March 5, 2009

Subject: UniStar Nuclear Energy, NRC Docket No. 52-016  
Calvert Cliffs Nuclear Power Plant, Unit 3  
Environmental RAIs No. 1001 through 1011

The purpose of this letter is to respond to the requests for additional information (RAIs) identified in the NRC letter to UniStar dated February 3, 2009 (Reference 1). The RAIs address figures needed to publish the environmental impact statement (EIS) and information necessary for completion of regulatory reviews.

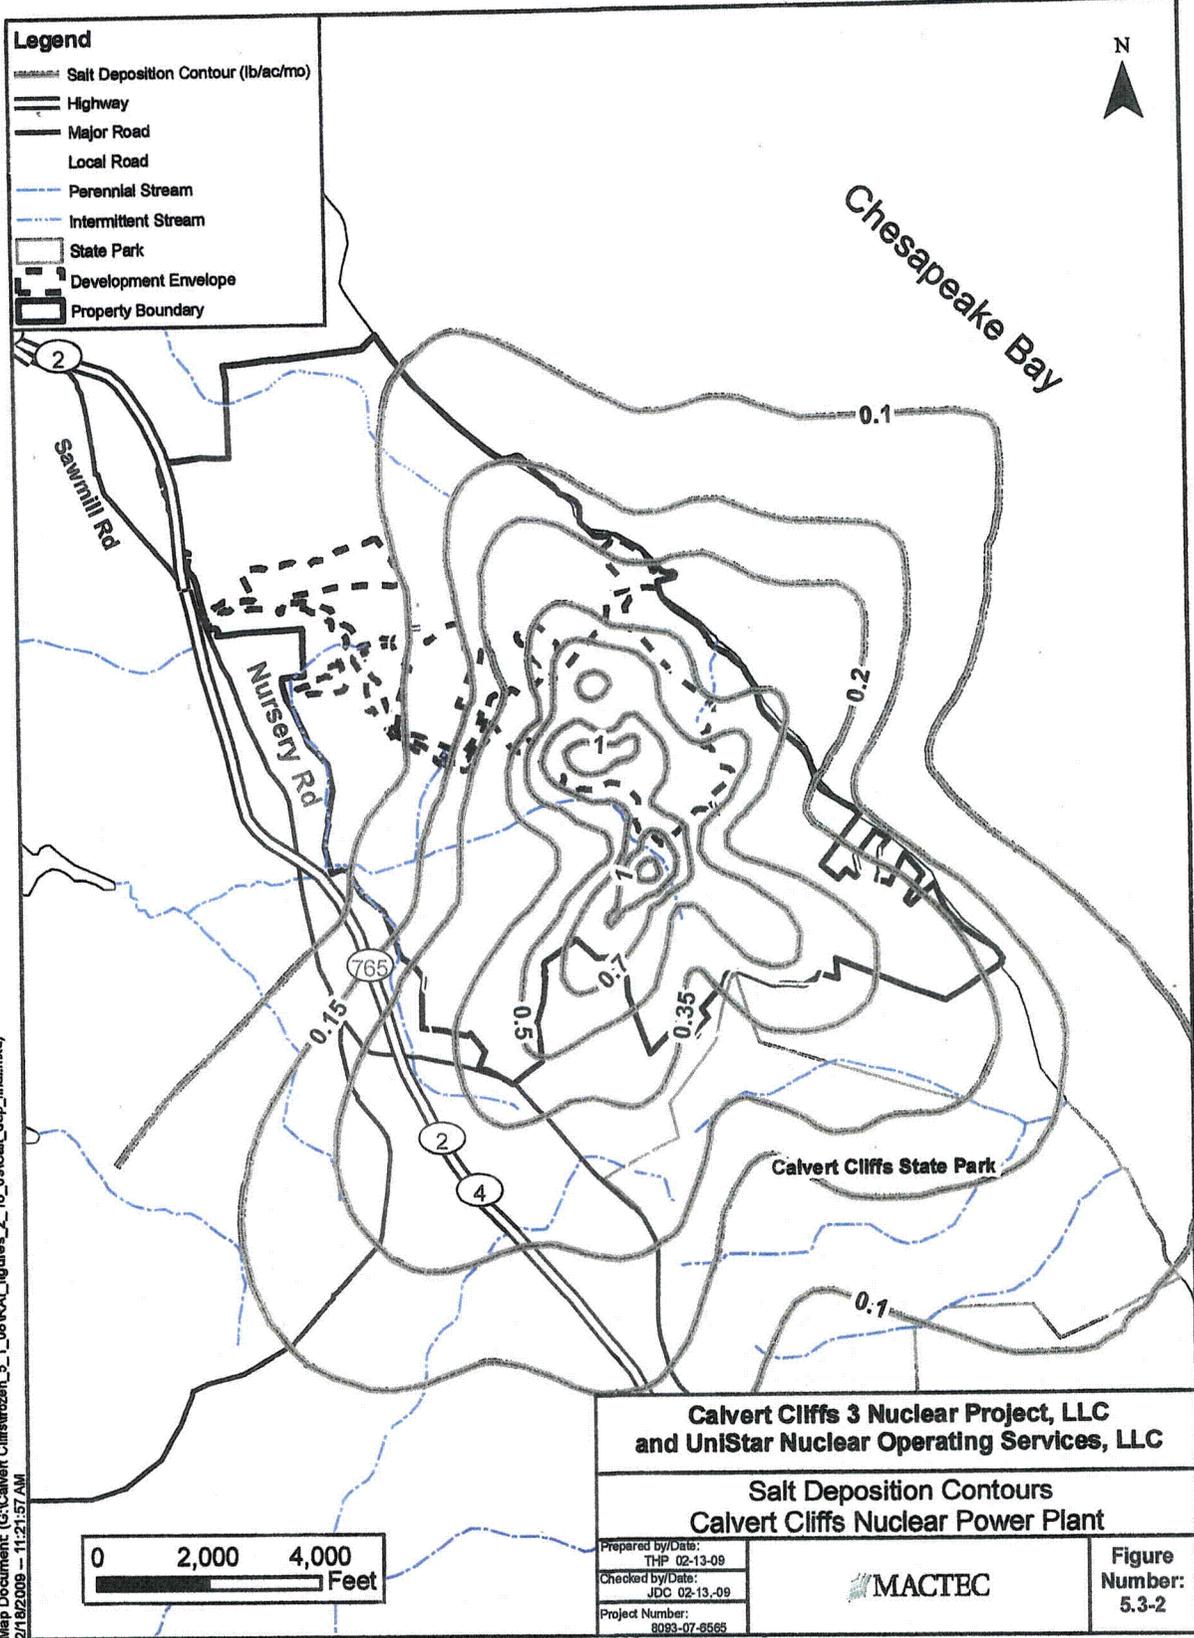
Provide legible graphics or GIS data for ER Figure 5.3-2.

UniStar has prepared a figure for use in the printed version of the EIS. See attached figure.

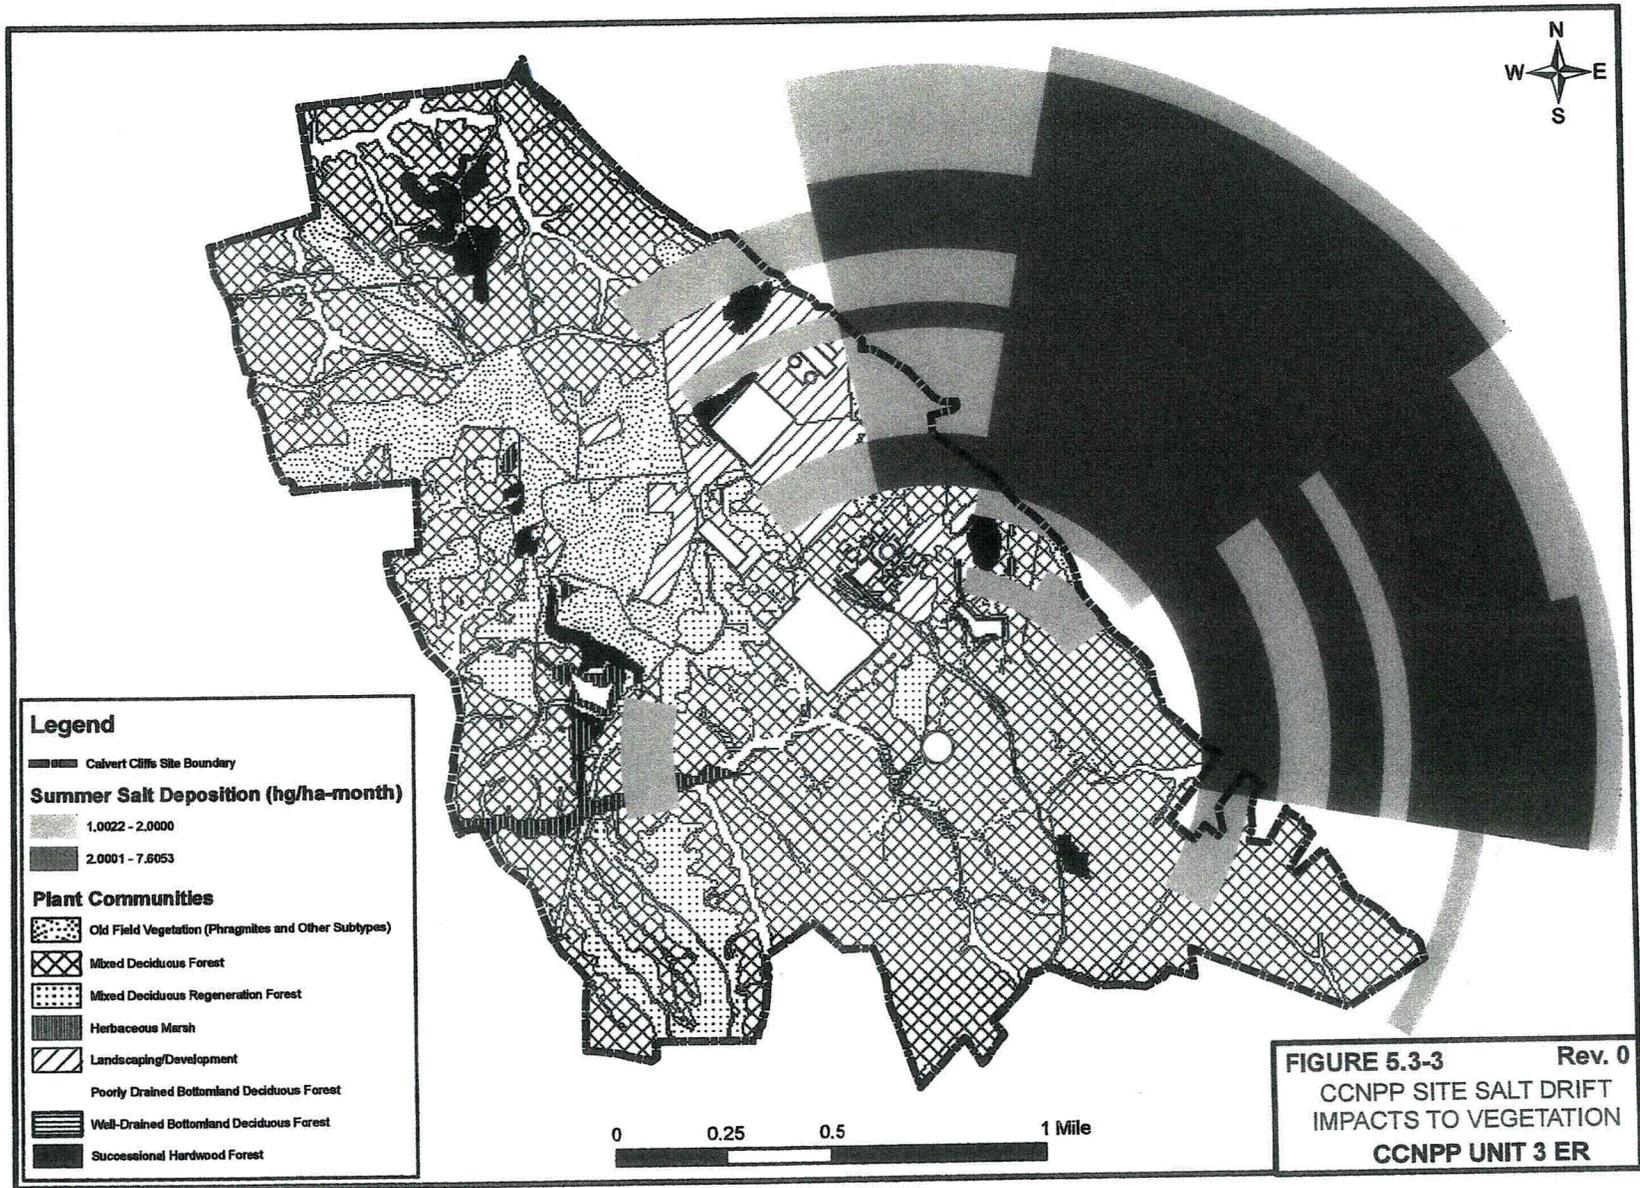
**Provide legible graphics or GIS data for ER Figure 5.3-3.**

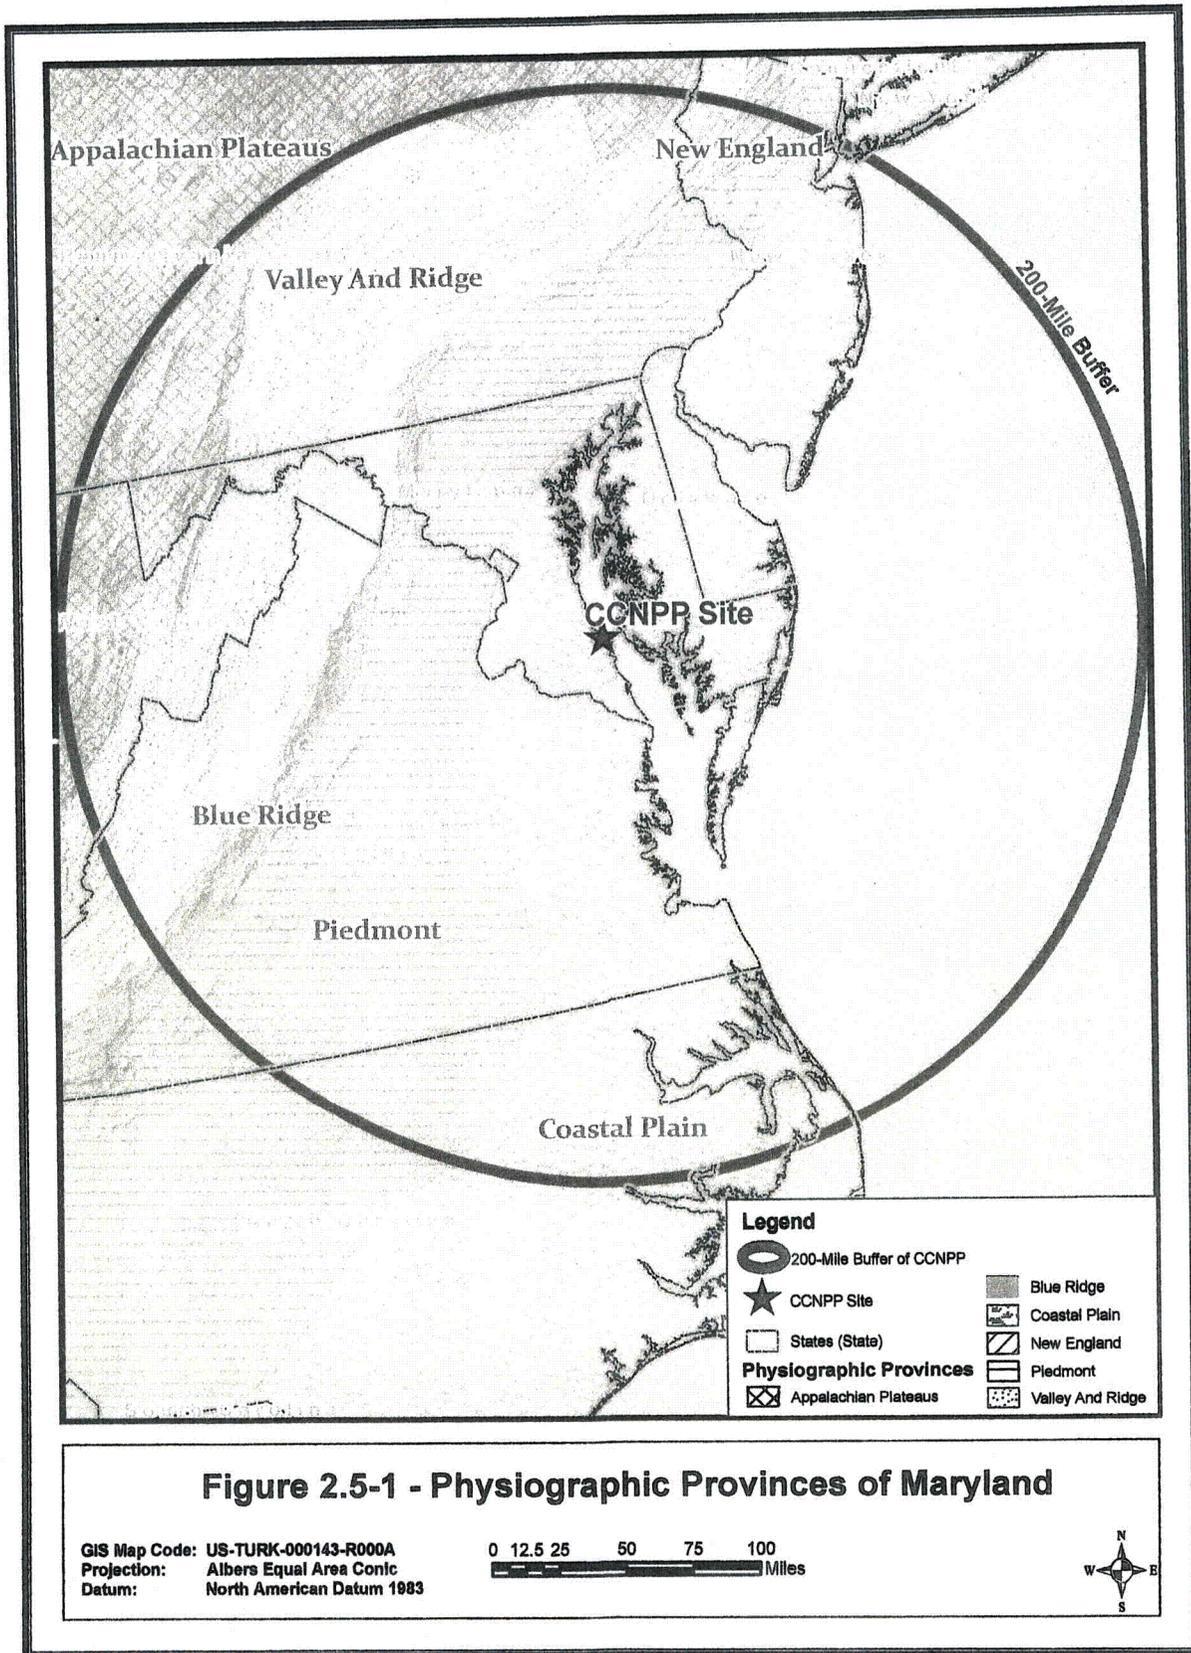
**Provide legible graphics or GIS data for FSAR Figure 2.5-1.**

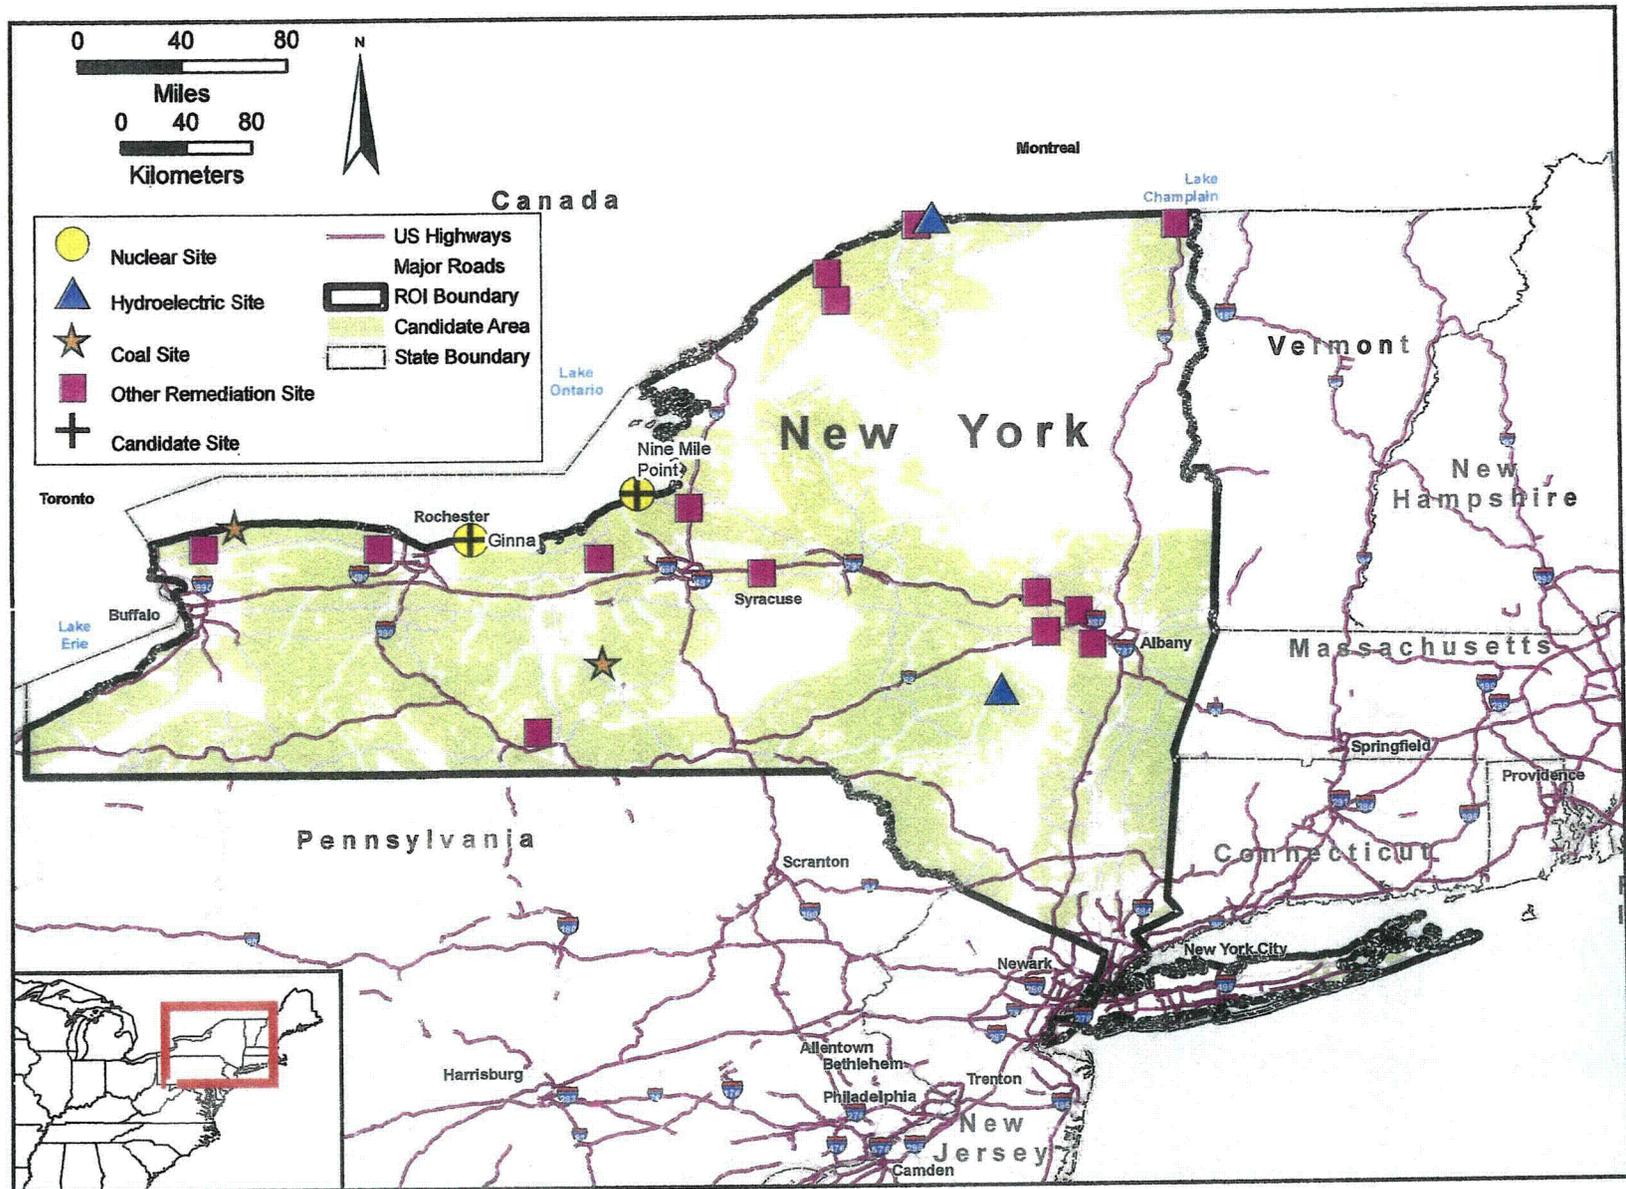
**Provide legible graphics or GIS data for August 18, 2008 RAI 198 Figure 9.3-3.**

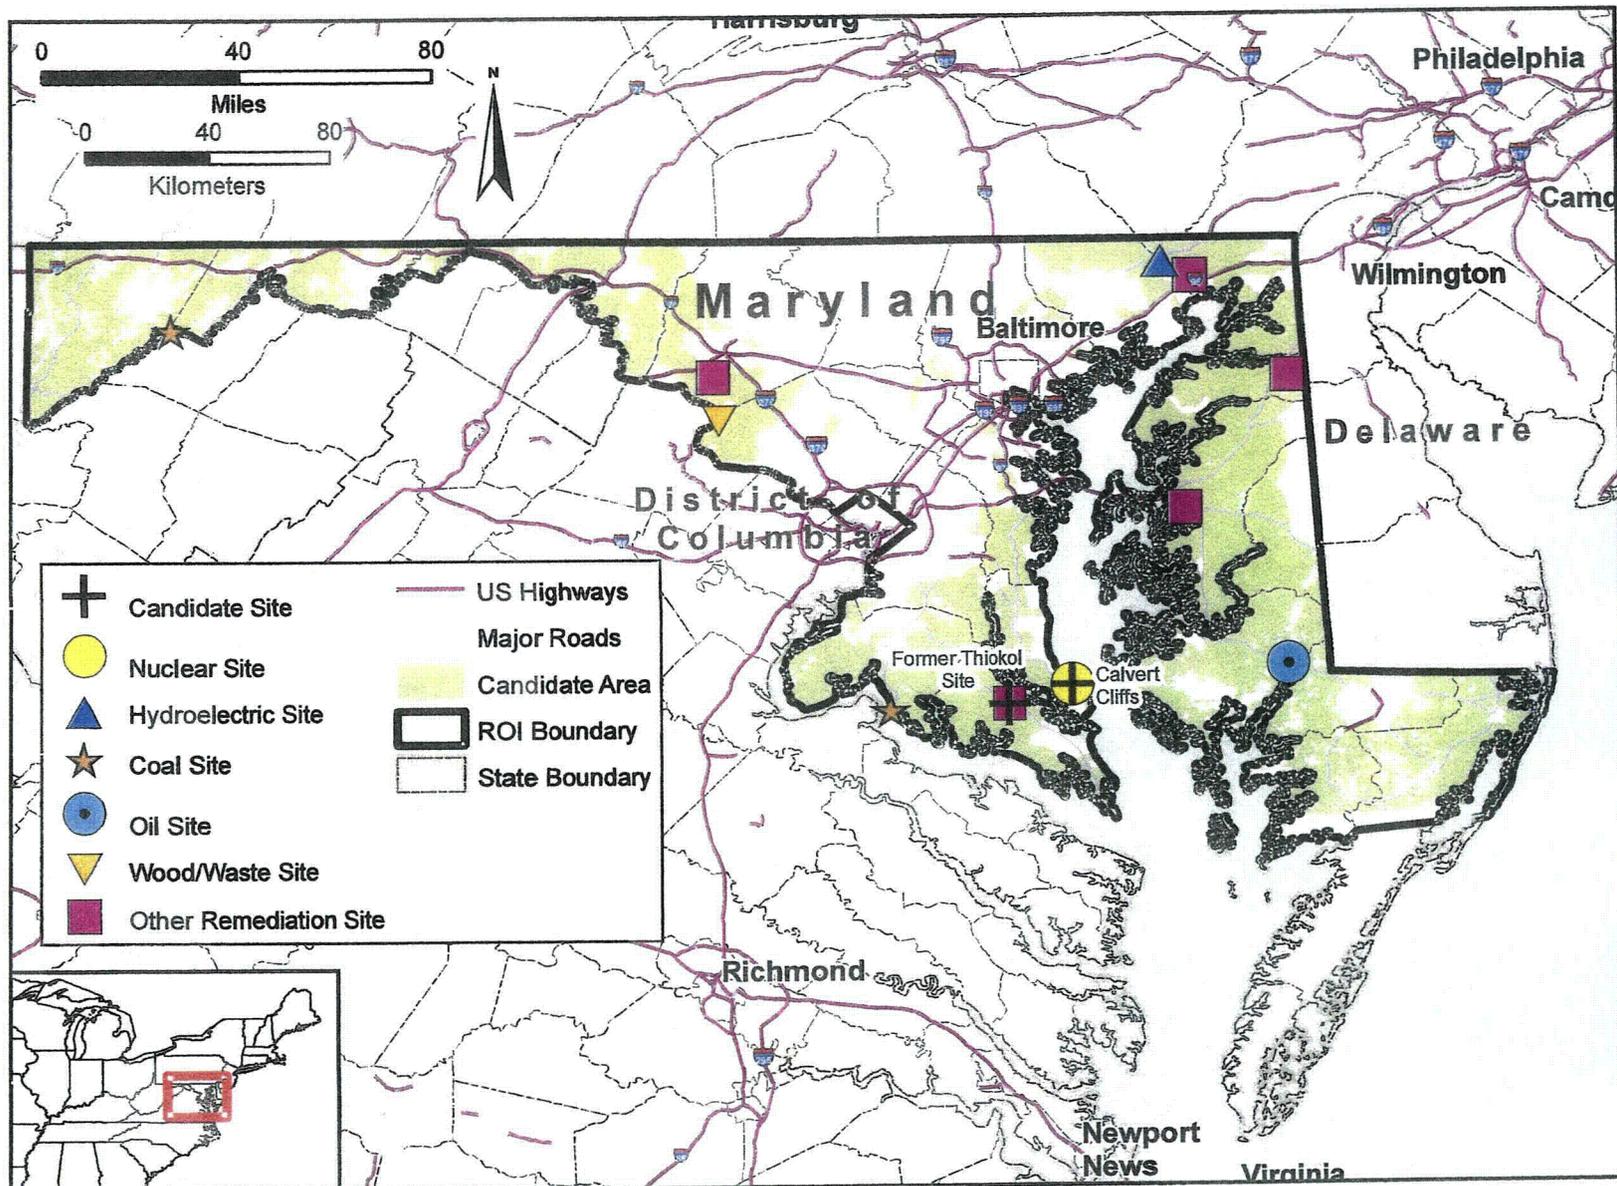
**Provide legible graphics or GIS data for August 18, 2008 RAI 198 Figure 9.3-4.**

**FIGURE 3**

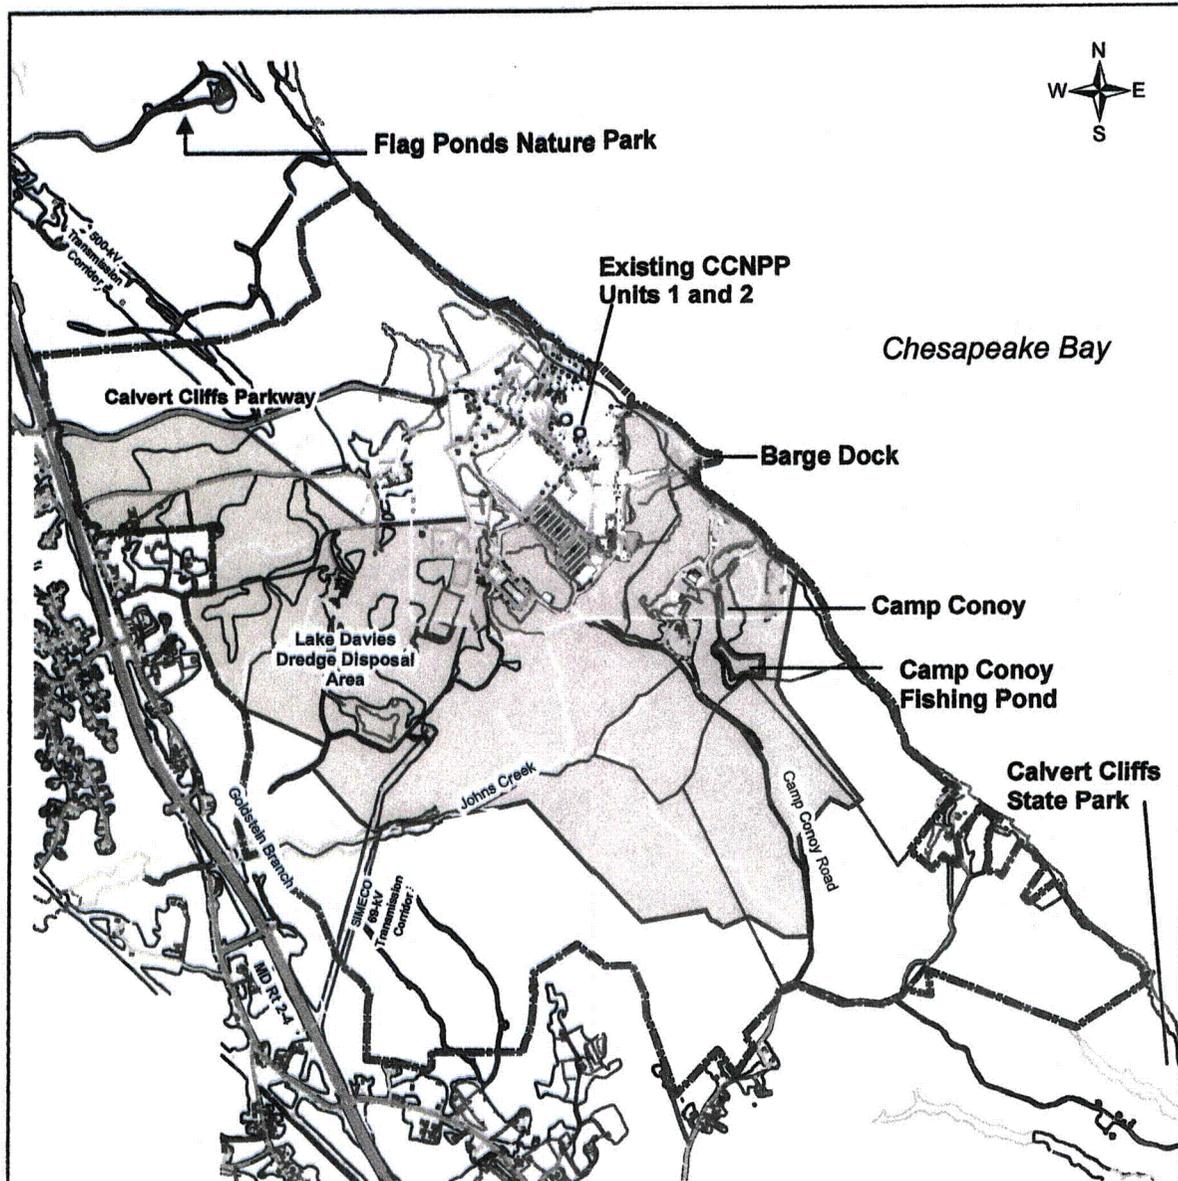
**ESRP Various – Graphics to be in color but reproducible in black and white:**  
Provide a legible graphic or GIS data for Figure 3 of the Final Wetland Delineation report for Proposed UniStar Nuclear Project Area Calvert Cliffs Nuclear Power Plant Site Calvert County, MA. 2007. Tetra Tech.

UniStar has prepared a figure for use in the printed version of the EIS. See attached figure.
